ppl
 PPL Electric Utilities

TITLE: 13881240	COUNTY: Northumberland	STATE: Pennsylvania	DATE: 03-04-2025
PROJECT NO:	PRINT NO: 1	NO. OF PRINTS: 1	ENGINEERED BY: KATAPULT
FILENAME: EXHIBIT A

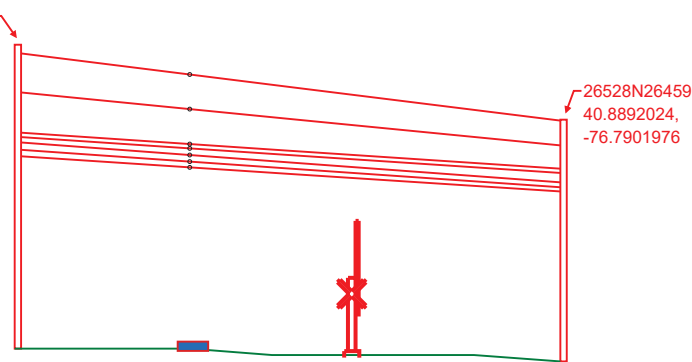
26525N26469
40.8894322, -76.7903487
> REPLACE 50-3 POLE WITH 55-2 POLE USING 7.5' BURIED DEPTH
> ENSURE NEUTRAL AT OR ABOVE 39'-0"
